**BRANN & ISAACSON**  
ATTORNEYS AND COUNSELORS AT LAW

**Re: New Development in the Lake Auburn Watershed after L.D. 2003, a New  
Maine Law**

**TO:** Eric Cousens, City of Auburn, Maine  
**FROM:** Laura Diemer, FB Environmental Associates  
**SUBJECT:** Revised Lake Auburn Watershed Delineation – Response to Peer Review  
**DATE:** December 14, 2022  
**CC:** Forrest Bell, FB Environmental Associates

**TO:** Eric Cousens, City of Auburn, Maine  
**FROM:** Laura Diemer, FB Environmental Associates  
**SUBJECT:** Response to CEI Peer Review of October 2021 Lake Auburn Study by FB Environmental Associates, Horsley Witten Group, and the University of Maine  
**DATE:** December 20, 2022  
**CC:** Forrest Bell, FB Environmental Associates  
**ATTCH:** *AWD Questions and Responses – Background (04378125xAE394) – FBE.docx*

Figure ES-1. Summary of estimated watershed boundary review by CDM Smith in their October 5, 2022 memorandum.

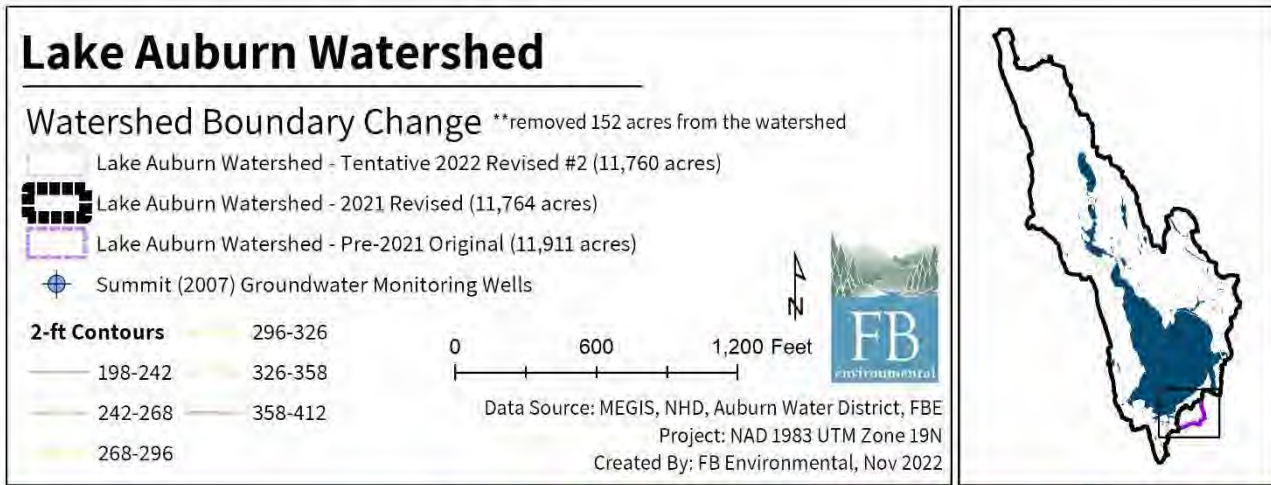
In short, CDM Smith found that the previous studies on groundwater flow “support the revised watershed delineation in some areas, and in other areas the data are insufficient to confirm a precise delineation.” CDM Smith notes three major segments along the watershed boundary line in question (refer to Figure ES-1 from CDM Smith’s October 5, 2022 memorandum copied here on pg. 3 for ease of comparison and FBE’s Figure 1 on pg. 4):

**Figure 1.** Tentative 2022 revision #2 (white dashed line) of the 2021 revised watershed boundary (black dashed line) compared to the pre-2021 original watershed boundary (purple dashed line) for Lake Auburn. Letters A, B, C, and D indicate start and end points of segments described in the text.

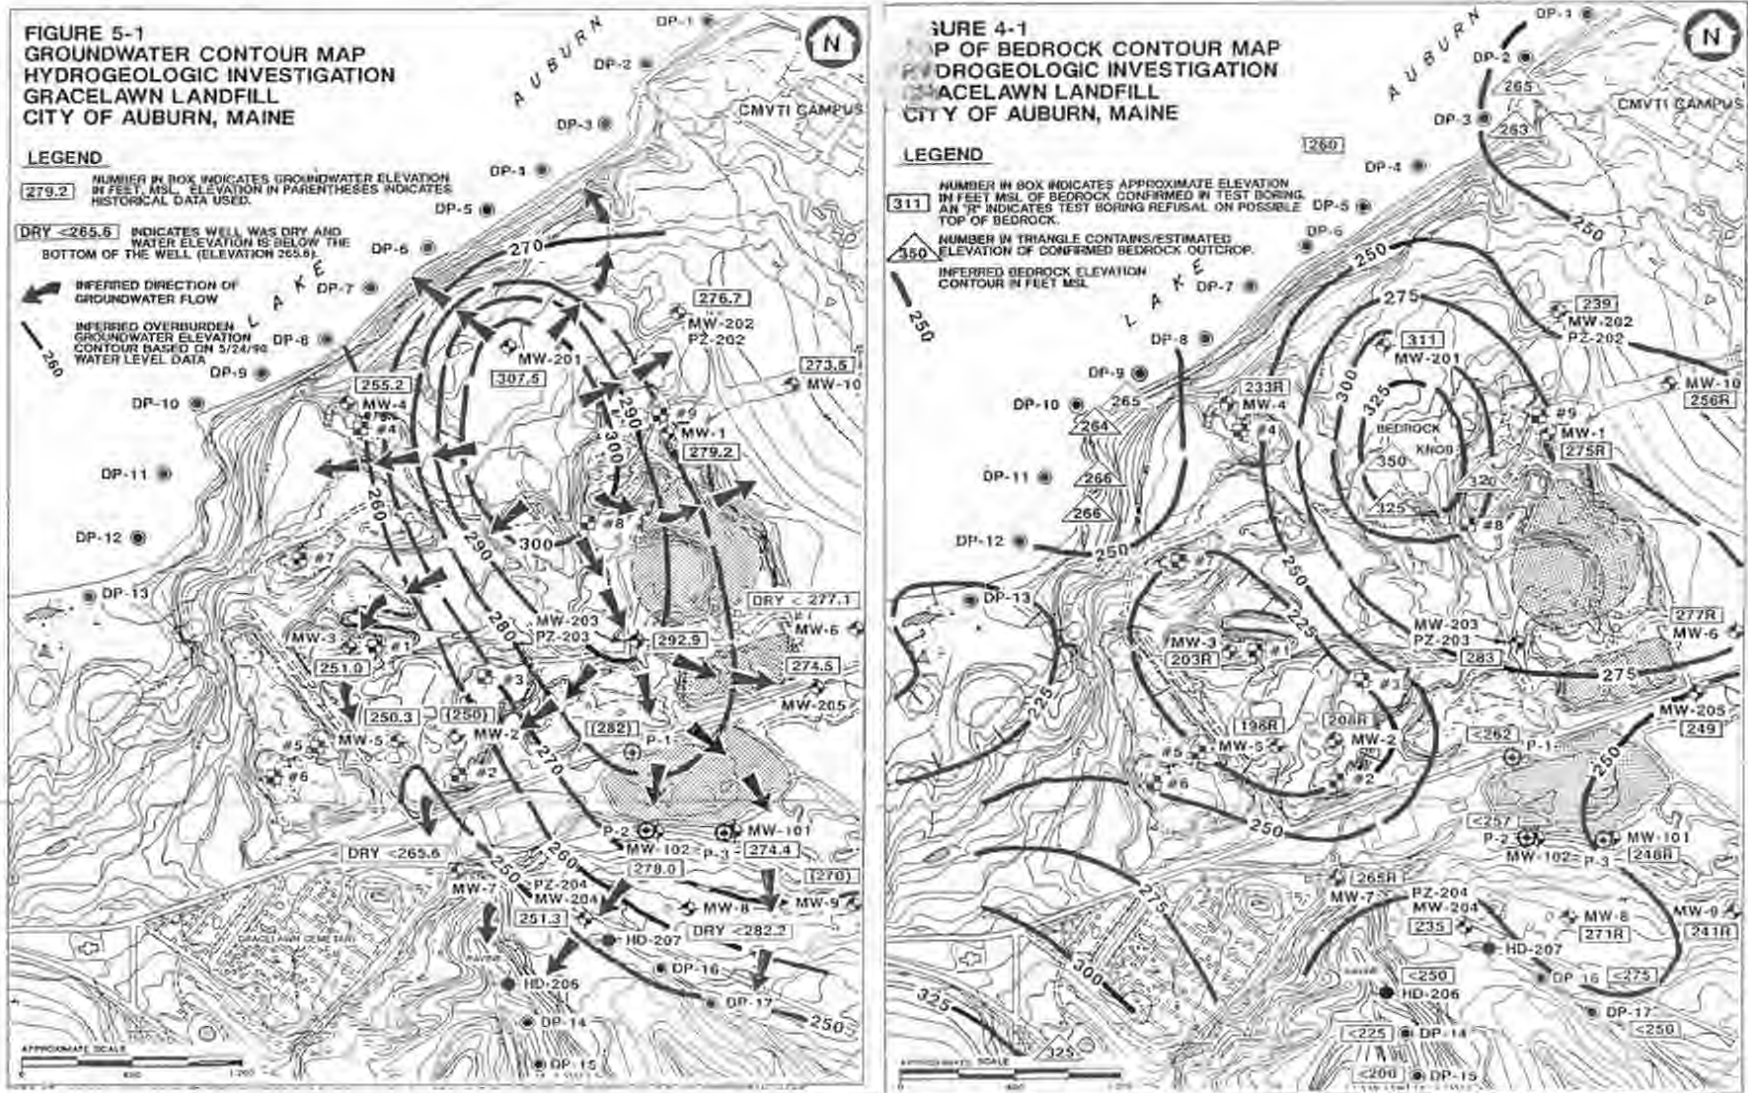
1. **Segment A to B (Figure 1):** The revised watershed delineation along the west side of the gravel pit from near MW-8 (Summit) to just before MW-1 (Summit) and MW-4 (E.C. Jordan) follows surface drainage topography. **CDM Smith concurs with FBE’s revised watershed boundary for this segment.**

2. **Segment B to C (Figure 1):** The revised watershed delineation around MW-1 (Summit) and MW-4 (E.C. Jordan) diverges from surface drainage topography to include a portion of the gravel pit depression. CDM Smith continues to follow surface drainage topography up to MW-1 (Summit) and MW-4 (E.C. Jordan). MW-1 (Summit) and MW-4 (E.C. Jordan) both showed groundwater levels below the lake surface elevation of 260 feet MSL, indicating that the direction of groundwater flow is likely to the south and away from the lake. **FBE concurs with CDM Smith that this segment of the watershed boundary should likely continue to follow surface drainage topography which would exclude the groundwater flow from around those two wells. Figure 1 provides a revised watershed delineation for this segment, which excludes an additional 4 acres from the Lake Auburn watershed (for a total of 152 acres from the original watershed boundary).**

3. **Segment C to D (Figure 1):** Near the middle of the gravel pit, there are a cluster of three triangles identifying an area of bedrock outcrop, called the “bedrock knob” in previous studies. CDM Smith notes that the well data from previous studies suggest that the bedrock outcrop is above lake level and contains groundwater within the bedrock; however, CDM Smith notes that it is unclear from the well data what direction(s) the bedrock groundwater flows. Water level data from E.C. Jordan well sites MW-1, MW-10, MW-301, and MW-206 indicate groundwater levels above lake level that flow in a northeastern direction, potentially to Lake Auburn or to a tributary stream of the Androscoggin River or some portion to both. For this segment of the watershed boundary line, CDM Smith indicates a “band of uncertainty” or a range of area (including FBE’s revised watershed boundary for this segment) that the watershed boundary line may reside. According to CDM Smith, the northern limit of their “band of uncertainty” follows surface drainage topography<sup>1</sup>. The southern limit of their “band of uncertainty” lies north of MW/PZ-203, P-1, MW-205, MW-102/P-2, and MW-101/P-3, all of which have well data that indicate groundwater flow away (south) from the lake. Summit well sites MW-2 and MW-5 showed water levels above

lake level. With water levels and bedrock elevations rising steeply moving to the east of those two wells, the outer extent of groundwater flow toward the lake is likely near these two wells (and just to the northeast), close to the start of the southern limit of CDM Smith’s “band of uncertainty” for at least a portion to the east of the “bedrock knob.” FBE based the revised watershed boundary primarily on surface drainage topography while also accounting for significant groundwater contributions from the gravel pit and “bedrock knob” area. To account for groundwater flow from the gravel pit, FBE relied on the groundwater contour map showing inferred overburden groundwater elevation and flow direction from E.C. Jordan (1990) with supplemental groundwater level information from additional Summit (2007) wells. FBE understands from CDM Smith’s review that the bedrock groundwater flow may not be captured in this map or in the revised watershed boundary (refer to Figure 2 on pg. 5). **FBE concurs with CDM Smith that the overburden/bedrock groundwater watershed boundary likely lies within their “band of uncertainty,” which includes the revised watershed boundary as it currently exists, and that additional data are needed to more precisely define this segment of the watershed boundary.**

**Figure 1.** Map adapted from Stoneybrook Land Use, Inc. Letters denote the start and end points of segments along the Lake Auburn watershed boundary line (refer to text).

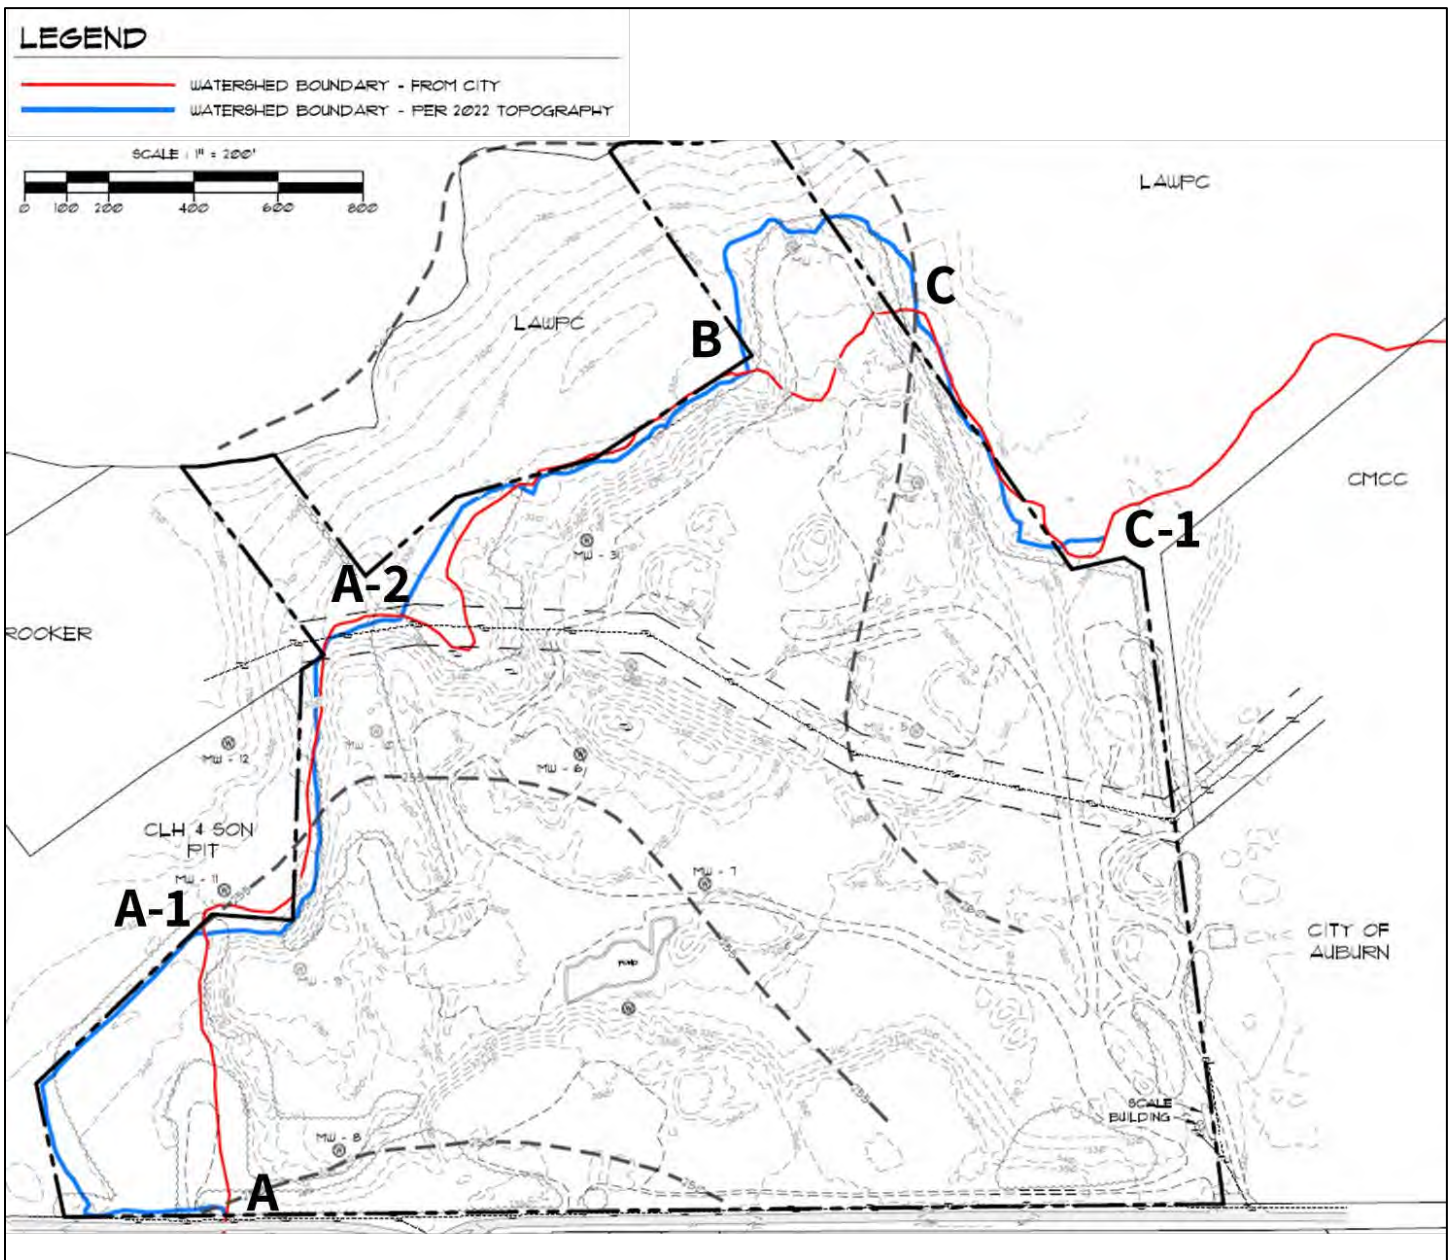
- **Segment A to A-1 (Figure 1):** Stoneybrook Land Use, Inc appears to follow the parcel boundary for this segment and not the surface drainage topography indicated on the map. The revised watershed boundary nearly follows the 2022 LiDAR topographic data and could be adjusted to more accurately follow surface drainage topography following field verification.

- **Segment A-1 to A-2 (Figure 1):** The revised watershed boundary and the watershed boundary drawn by Stoneybrook Land Use, Inc based on 2022 LiDAR topographic data generally match well for this segment but could be adjusted to more accurately follow surface drainage topography following field verification.

- **Segment A-2 to B (Figure 1):** The revised watershed boundary at the beginning of this segment follows the 350’ elevation high point plateau, but the 2022 LiDAR topographic data show descending elevations to the northeast that may drain into the gravel pit, outside of the Lake Auburn watershed. The remainder of the segment matches well between the revised watershed boundary and the watershed boundary drawn by Stoneybrook Land Use, Inc. We recommend that the revised watershed boundary be reviewed in the field and adjusted accordingly.

- **Segment B to C (Figure 1):** FBE concurs with the watershed boundary drawn by Stoneybrook Land Use, Inc based on the 2022 LiDAR topographic data, as per FBE’s tentative revised #2 watershed boundary in FBE’s “*Revised Lake Auburn Watershed Delineation – Response to Peer Review*” December 14, 2022 memorandum to the City of Auburn. We recommend that this segment be verified in the field and adjusted accordingly.

- **Segment C to C-1 (Figure 1):** The revised watershed boundary and the watershed boundary drawn by Stoneybrook Land Use, Inc based on 2022 LiDAR topographic data generally match well for this segment but could be adjusted to more accurately follow surface drainage topography following field verification.

- Segment C-1 to D (Figure 1):** The 2022 LiDAR topographic data were collected for a portion of the revised watershed boundary in question and do not cover this segment, which was part of FBE’s “*Revised Lake Auburn Watershed Delineation – Response to Peer Review*” December 14, 2022 memorandum to the City of Auburn.
